City of Plymouth Planning Commission Special Meeting Agenda Wednesday, October 27, 2021 – 7:00 p.m. ONLINE Zoom Webinar

**Site Plan Review
For
Plymouth, Michigan**

Subject: Response to Review Comments
Plan Review
1115 S. Main Street
6/25/2021

RE: E.G. Nicks – Revised Site Plan Materials

SITE PLAN
Scale: 1" = 10'-0"

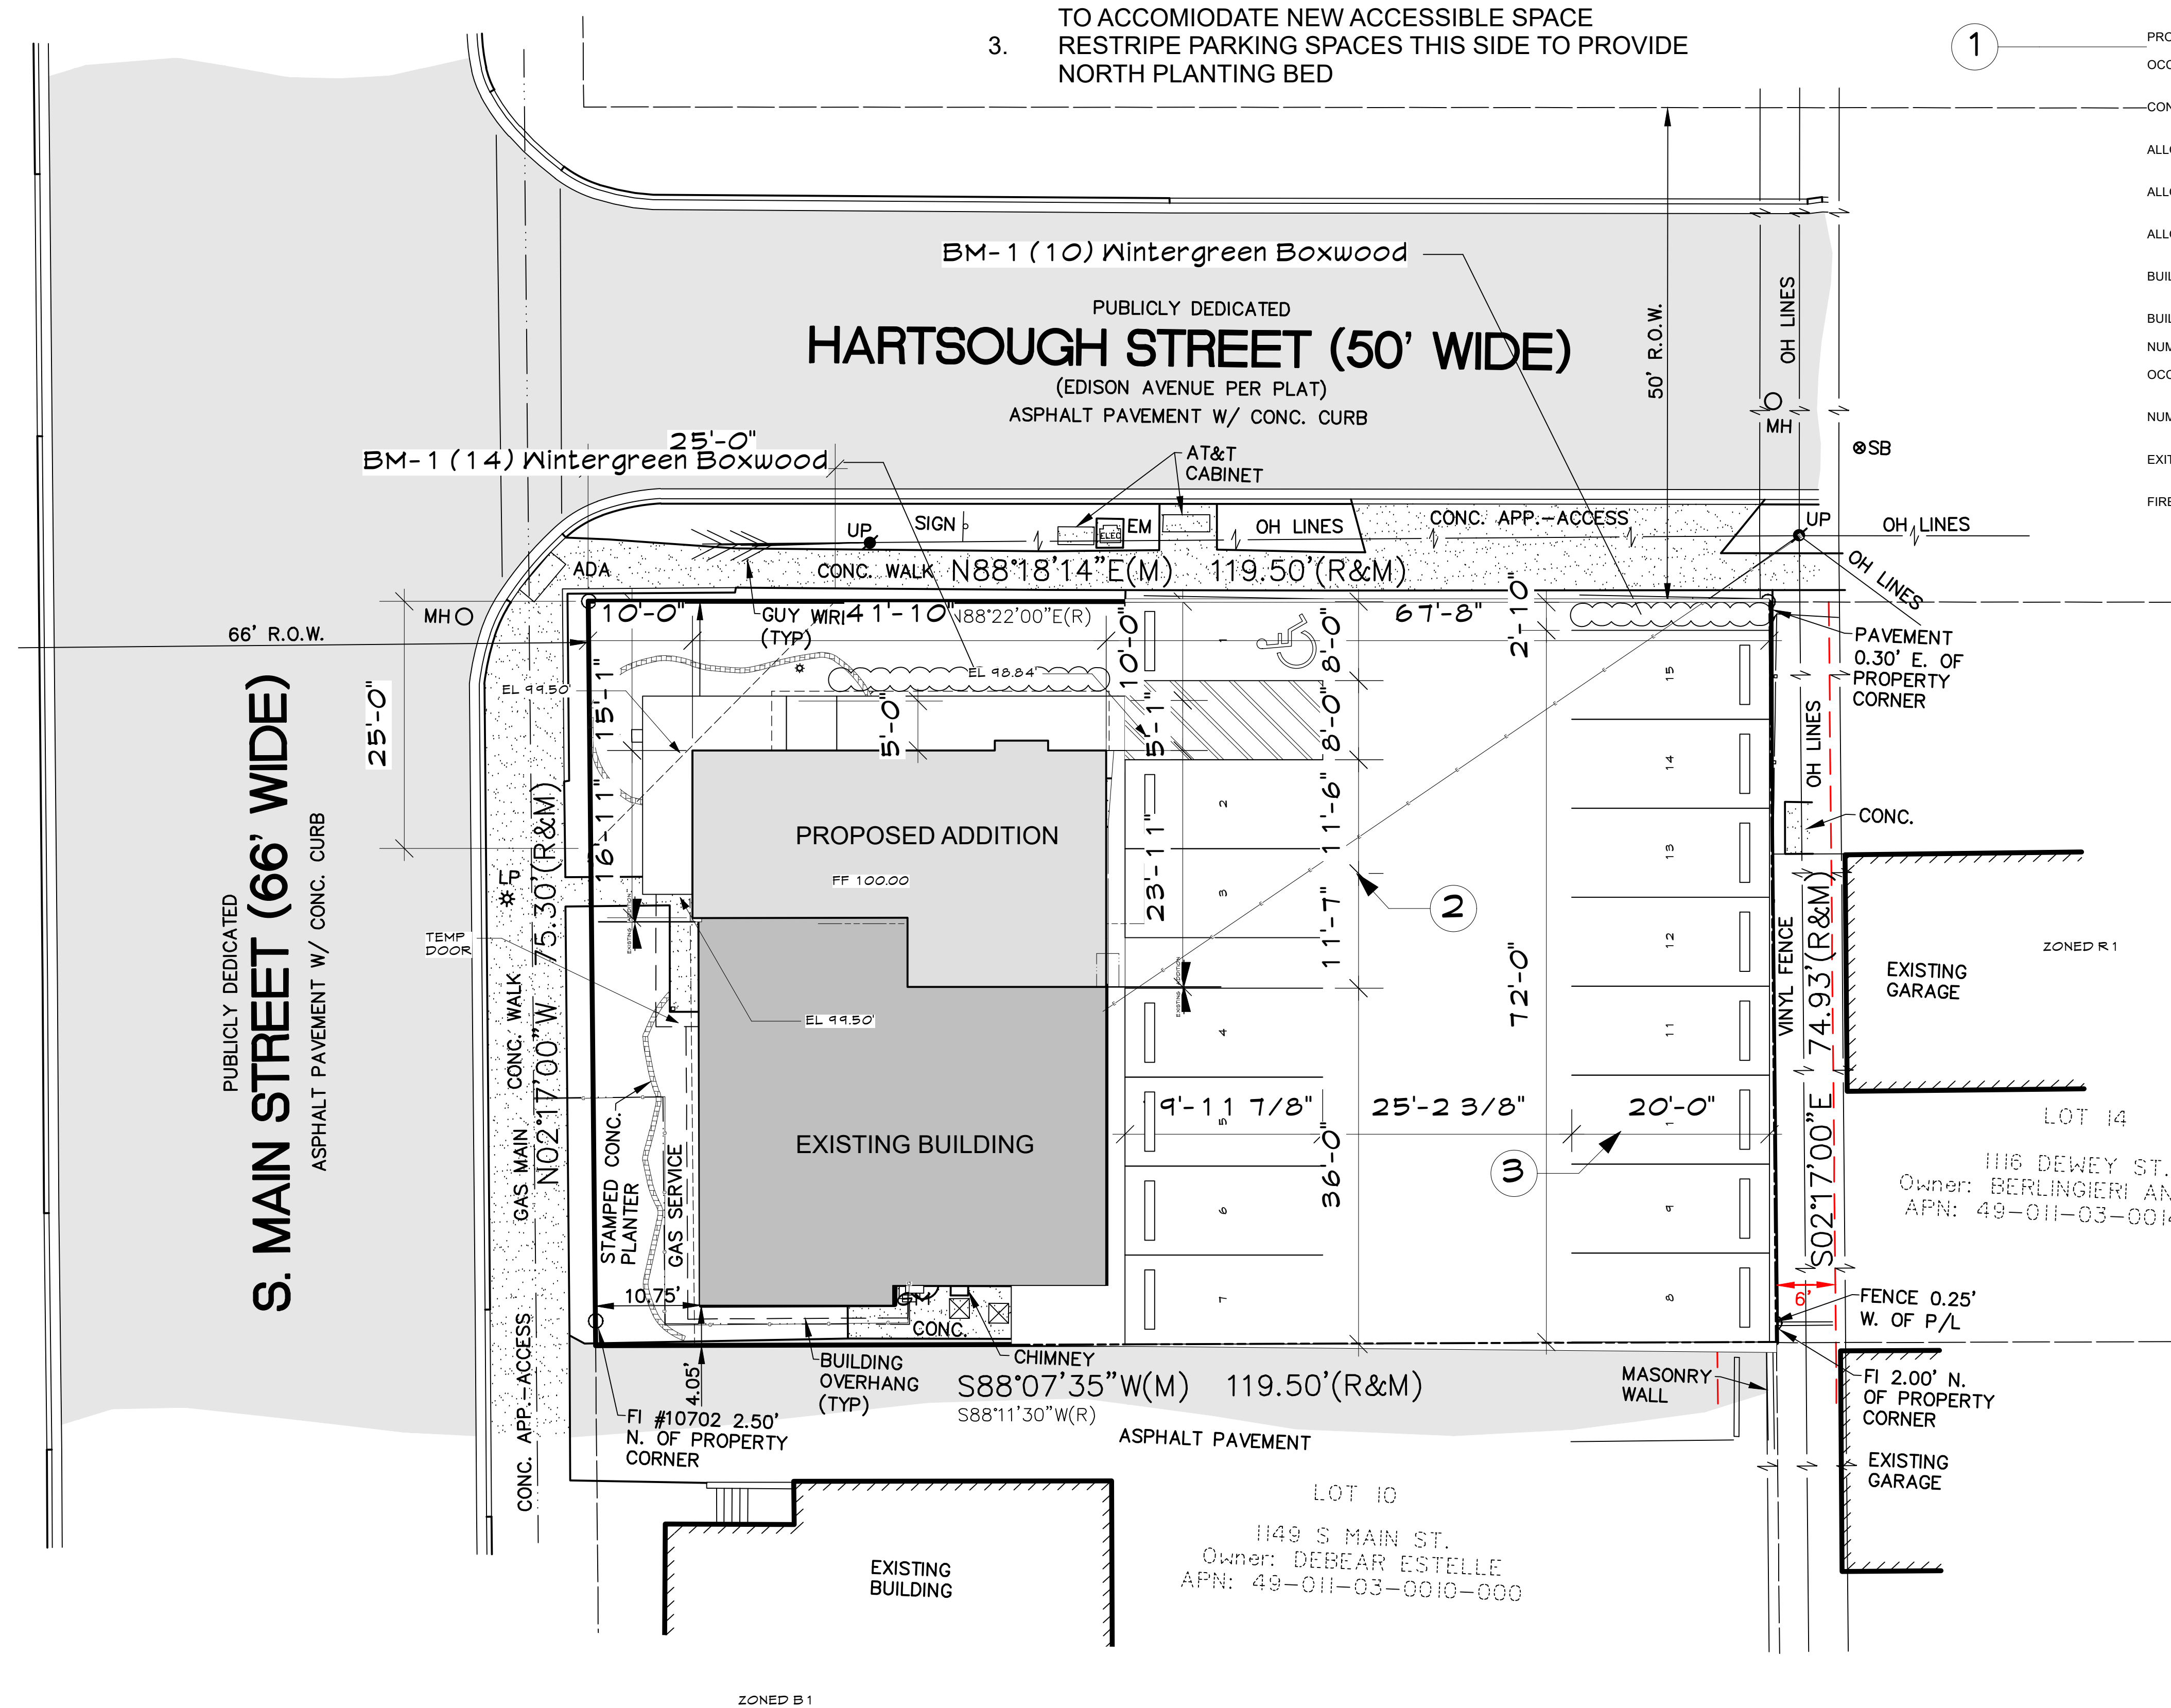
Sheet A0.2 shows the proposed sign to be located in the clear vision area. To be permissible, the sign must not exceed 30-inches in height. A sign detail is shown on Sheet A0.2. The sign is shown at 5.08 feet tall, which exceeds the maximum allowed in the clear vision zone. To keep this location and proposed sign, the applicant will need to obtain a variance.

The site plan on Sheet A0.1 proposes to plant 14 boxwood along the new porch that faces Hartsough. (Note: all landscaping requirements for this project relate to the parking lot, and are discussed above.)

The proposed lighting is shown on Sheet A0.2. This sheet proposes two new, pole-mounted light fixtures in the parking lot; one on the east side and one on the west side. The photometric information provided on this sheet shows the light levels meet the 0.1 maximum footcandles at the property line to the residential use to the east. The plans indicate that this fixture comes with a house-side shield, and the illustration implies that the fixture is downward facing. However, the applicant needs to provide information about whether the fixture is non-glare, color-corrected fixture, and that the lighting source is not directly visible from adjoining properties at the proposed height.

The proposed height of the parking lot lights is 20-feet. The ordinance only permits fixture height up to the height of the building if it is less than 25-feet tall, or unless modified by the Planning Commission. The height of the ridge of the existing building is 21.5-feet, making the proposed fixtures slightly shorter than the height of the building. The Planning Commission may modify the height of the light fixtures, based on consideration of the following:

Parking lot lighting has been added to the project. Please see sheet A0.2

Please see sheet A0.2 for sign details
